STAFF REPORT: MARCH 25, 2025 MEETING

APPLICATION NUMBER: HDC2024-00599

ADDRESS: 1610 EDISON

SCOPE: INSTALL WINDOWS AT REAR PORCH

Left: Rear walls of (from left) 1602, 1610 and 1616 Edison. Staff photo, February 2025.

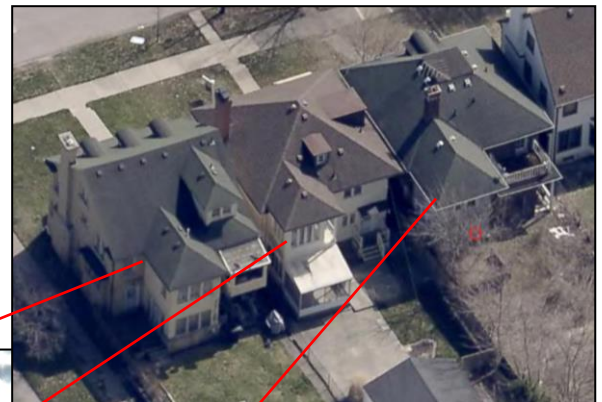
- Moving to the rear of the lot, staff noted that the three houses on the northwest corner of Edison and Woodrow Wilson have similarly-designed rear extensions. With the two-story massing, hip roof and flat wall space and multiple grouped window openings, the second floors of the extensions were likely sleeping/sun porches that were enclosed many decades ago. Based on the condition of the enclosures, staff believes the overall design and placement of these extensions are historic age and still read as early 20th century architectural building components.

Comparison of the three walls of the rear extension. Each lower wall is finished in a different manner. Applicant photos.

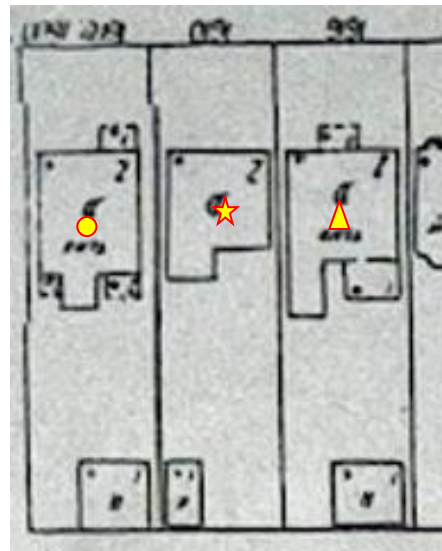
- The dissimilar design treatment to the half-walls below the grouped windows, and the small open porch suggest the exterior walls were modified at some point in time. The white aluminum railing matched the design of the 1970's-era aluminum railing at the front porch (a photo comparison of the front and rear porch rails is on page 8), so it is possible these walls were changed at that time.

- While the exterior wall materials have been altered and an open porch integrated into the second floor footprint extension, the combined effect of the existing massing, height, hip roof, and grouped window openings with historic-age wood casement windows, still conveys the architectural and historic association of an early 20th century two-story porch extension, and staff considers it a character-defining feature of the dwelling and property.

Interior and exterior views of the rear-north wall and windows. Applicant photos.

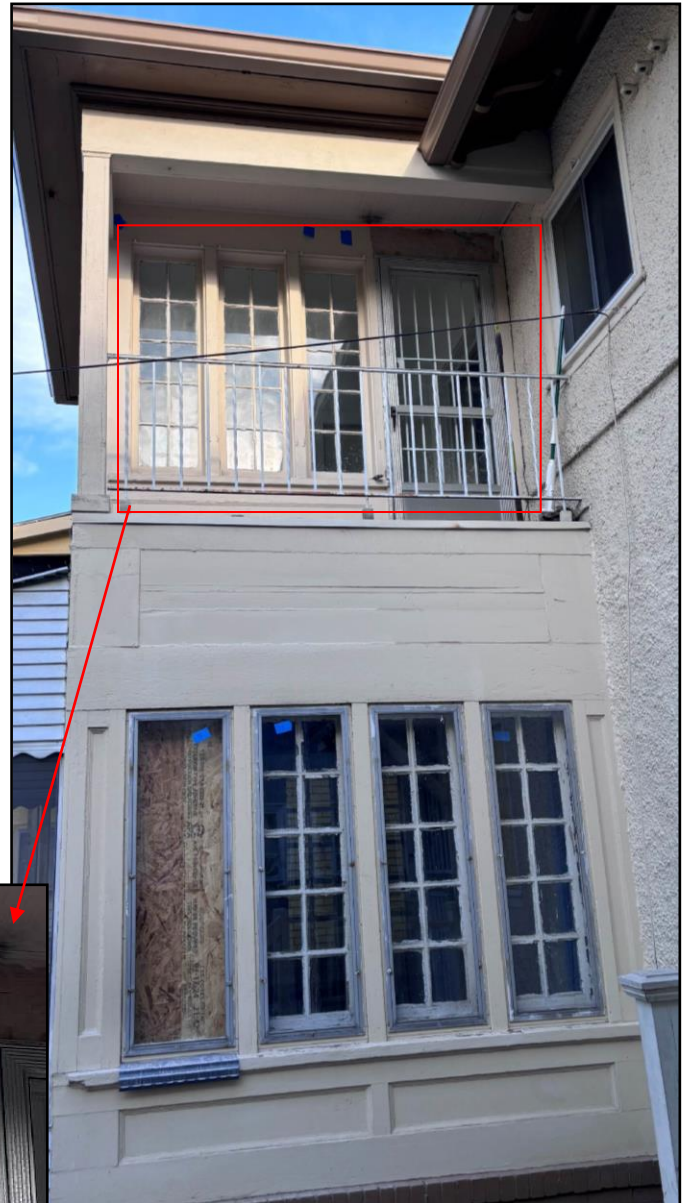
- The interior and exterior photos submitted by the applicant show the windows to be intact (with the exception of one missing window on the east wall) and in repairable condition.
- The applicant mentions in the “Description of Existing Conditions” part of the application form, that the water problems which caused deterioration to the interior porch walls are directly related to the current sills and how they were constructed. It is possible to fabricate new sills (and mullions, if needed) and reinstall the existing casements after the windows are repaired.

- The close-up exterior views of this set of windows, as shown below, confirm their deep placement within the walls.
- The existing exterior wood wall treatment may have been in place at the time of designation and is a compatible material and wall finish for the house; therefore, staff does not consider this a violation.
